REGIONAL REVIEW FINDING

ARC REVIEW CODE: R1208241

Name of Proposal: Camden Paces
Submitting Local Government: City of Atlanta

Description: This project, located in the City of Atlanta, is a proposed mixed use project with 114,000 square feet of office space, 117,000 square feet of commercial space and 390 residential units. This DRI review will also include an adjacent project by the same developer and name (Camden Paces, DRI #2281) which was not reviewed as a DRI previously due to it being below DRI thresholds. That development included 392 residential units. Including both developments, this DRI review will include 114,000 square feet of office space and 117,000 square feet of commercial space and 782 residential units. The project is located at 77 East Andrews Drive NW in the City of Atlanta.

ZP-1

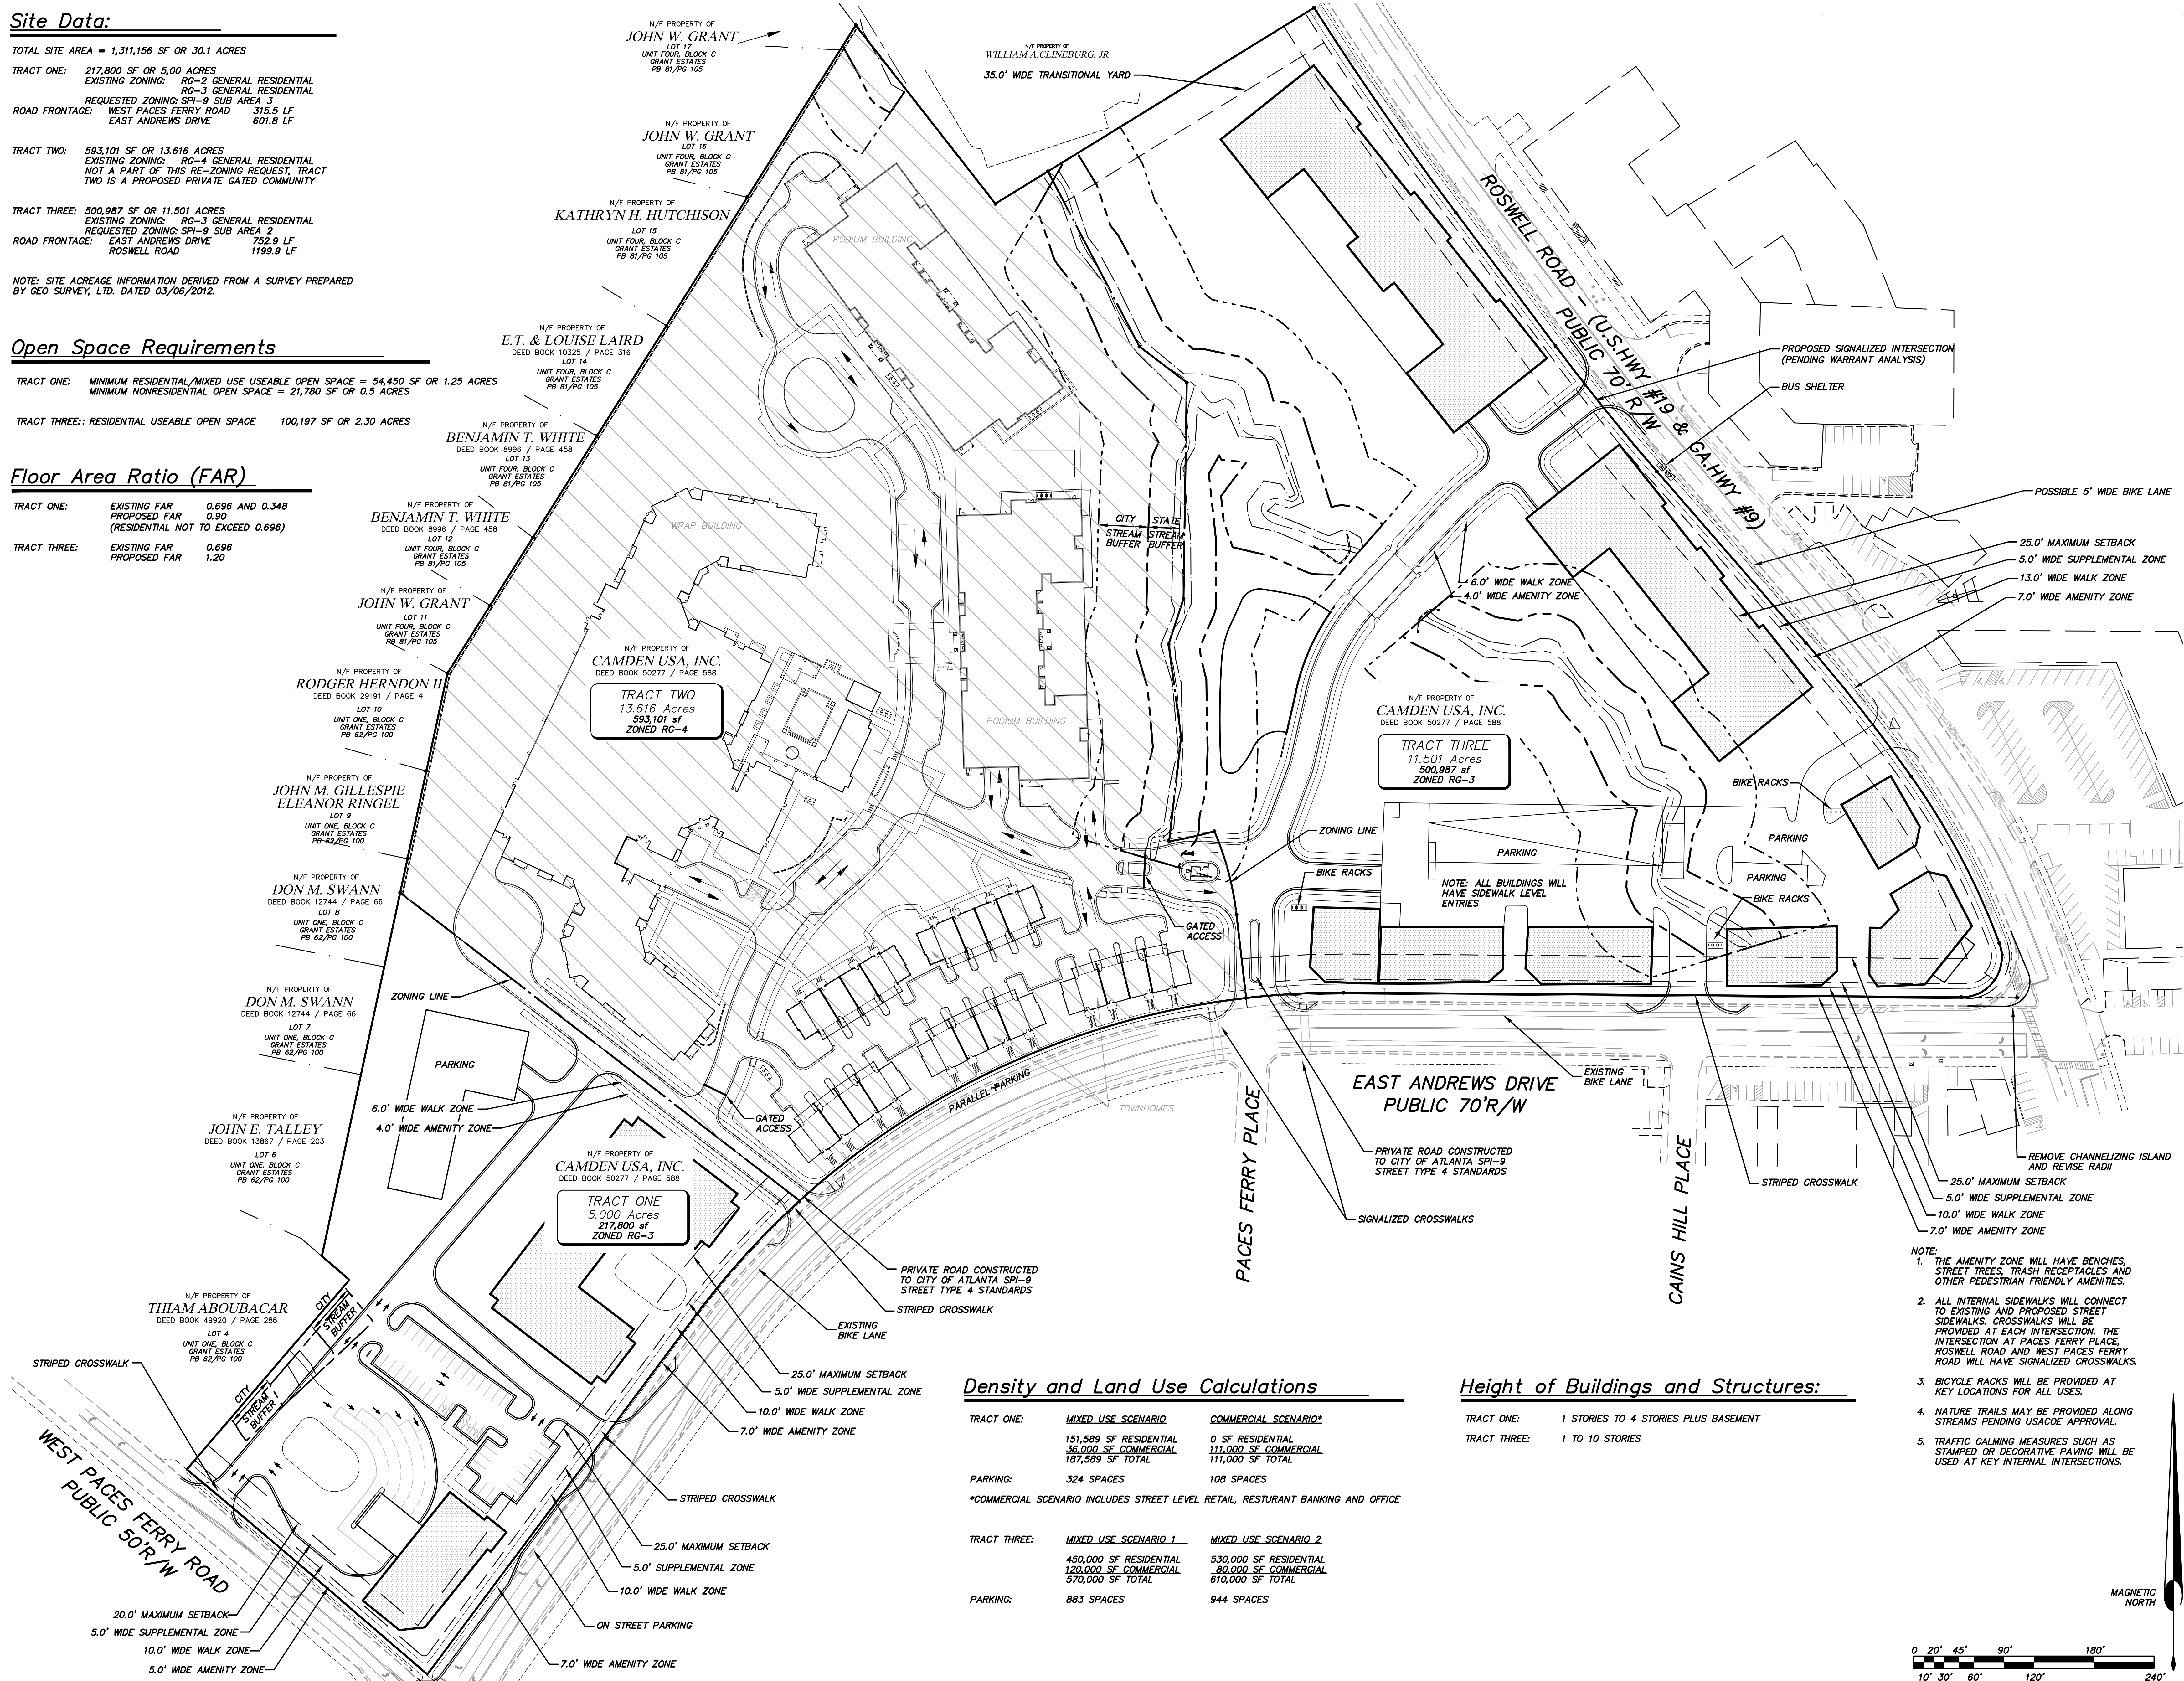
The development proposal includes several good features and design elements including buildings facing and being brought up to the street, parking placed behind or beside buildings and screened from view, internal connectivity and public access through the site, bicycle and pedestrian facilities, and a mix of uses that may encourage residents, employees, and visitors to the development to walk rather than drive between the various uses.

However, the portion of Camden Paces that was not reviewed and has already been zoned includes multiple gates which restrict movement through the site, without having to exit the property and use an external street. It was indicated during the pre-review meeting that the gates have already been moved from a previously proposed location.

While the new placement of the proposed gates allows for additional access into and through the site, the developer should consider using gates only at the entrances to the residential parking area opening the central drive to all residents and visitors of the development. Doing this would allow multiple connections between the various development pods and uses within the site.
